Planning Report

Perimeter West, PCD, Subarea 1 – Poet’s Walk

16-022INF
Informal Review
Assisted Living & Memory Care Facility
Perimeter Drive

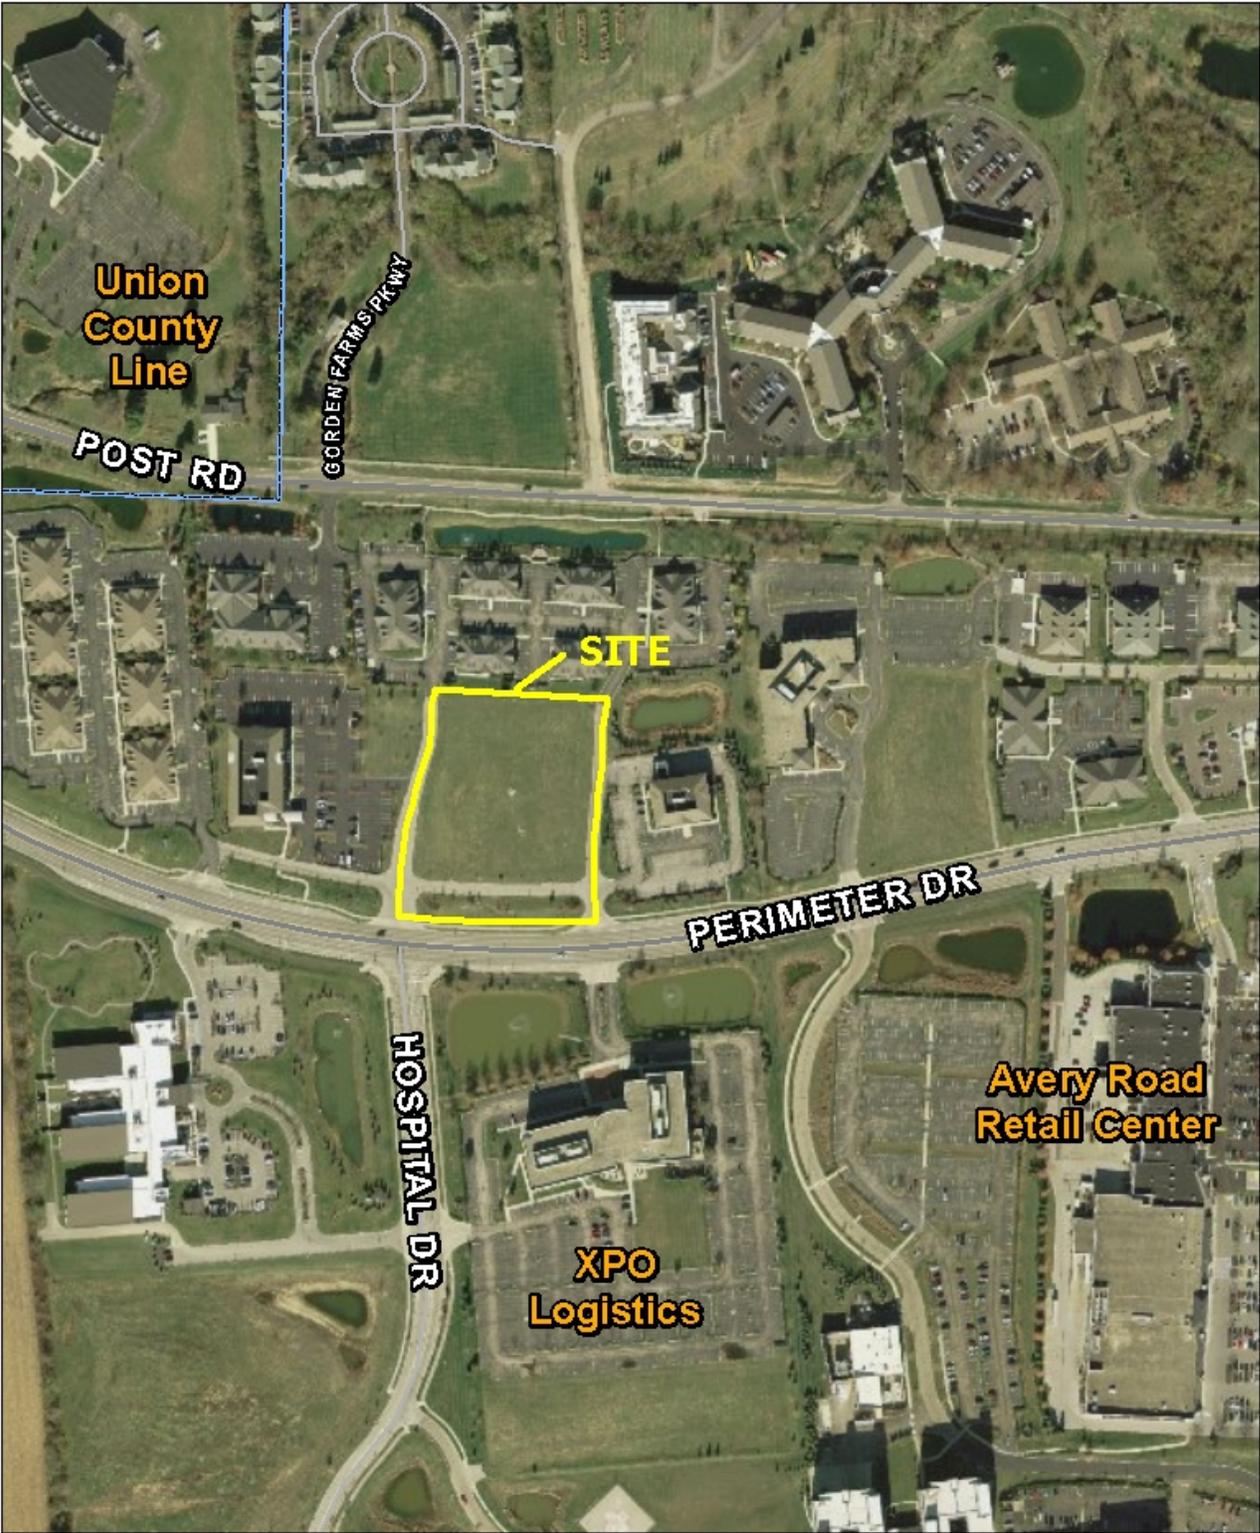
Analysis		Informal
General	<p>Planning recommends the Commission consider this proposal with respect to the site layout, site access, circulation, building orientation and stormwater management. The following analysis provides additional details.</p>	
<p><i>Discussion Questions</i></p> <p>1) Is the proposed layout and circulation appropriate for</p>	<p>The proposed building and parking location with the front elevation facing west, misses an opportunity to create an architectural edge along the Perimeter Drive frontage. The proposed dumpster location facing south to a main commercial corridor within the City needs to be revised. Access to the refuse collection must be accommodated on site. Access to the site is provided from curb cuts that do not align with adjacent access points. Although the internal circulation is</p>

Analysis		Informal
this proposal?	<p>private, aligning curb cuts is a preferred practice to avoid vehicular conflicts.</p> <p>While limited design details are required at the informal stage, the applicant will need to consider the placement of outdoor amenities, which have been challenging for similar facilities in Dublin, including the consideration for the height of fences. The applicant will also need to consider pedestrian circulation and accessibility for this development at the formal application stage.</p>

2) What architectural considerations should the applicant make for this proposal?	<p>The layout, general building design, and architectural character of the proposed building are demonstrated in supporting information that has been submitted along with this application. At this stage in the process, specific exterior designs have not been completed for this site. Brick and/or stone will need to be significant elements on the exterior façade of the building. The final architecture of the building will be required to be designed to fit in with and complementary to the general aesthetic character of buildings in the general vicinity of the property.</p>
